The Independent Expert (Brain Hemsworth) made comments on the *Noise Scheme of Assessment (NSoA)* for *Route Section E* on 1st July 2015. The key concern was that the location of “Dr Booths C.E School” should be correct in the NSoA, and that it has been considered in the NSoA. The relevant extract from the original IE comments are as follows:

This note responds to those concerns by identifying the building, its location, the predicted noise levels and the need for noise mitigation.

Figure 2.1 *Modelled School Building*

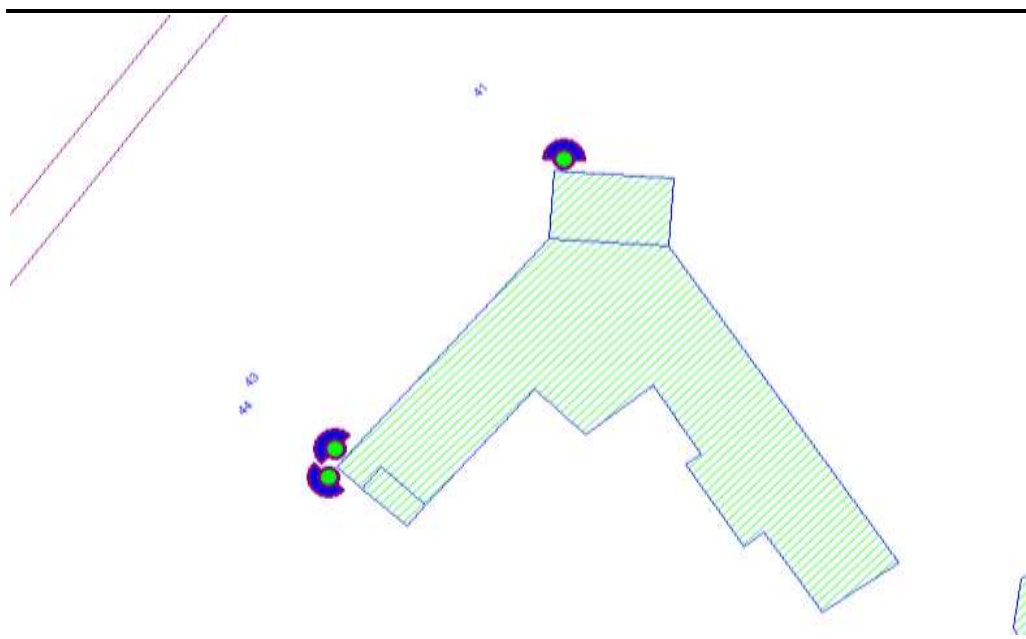
“1. Operational impacts are discussed in Section 6.4.2 but Dr Booth’s C.E. Primary School is not included. Neither is it identified as a Noise Sensitive Receptor in the NSoA for Route Section E or any geographical data for its location relative to the railway or noise levels given. Since it was not included on the NSoA it was not possible for me to comment on noise levels.

Some reference to and assessment of Dr Booth’s C.E. Primary School should have been contained in the NSoA for Route Section E and its omission should be addressed by ERM either by explanation of why it was omitted or by carrying out an assessment.

Criticism was correctly made that Dr Booth’s Primary School was incorrectly placed on the NSoA maps. This should be addressed as in comment 1”.

ERM has reviewed the mapping and maintains that the School is correctly included in the noise modelling. *Figure 5.1* in the NSoA showing the noise contours does include the building, although it is recognised that the label is some distance from the School. Although results are not tabulated for this receptor specifically, it was taken into account when designing the mitigation. The School and the proposed railway lines as modelled are shown in *Figure 2.1*.
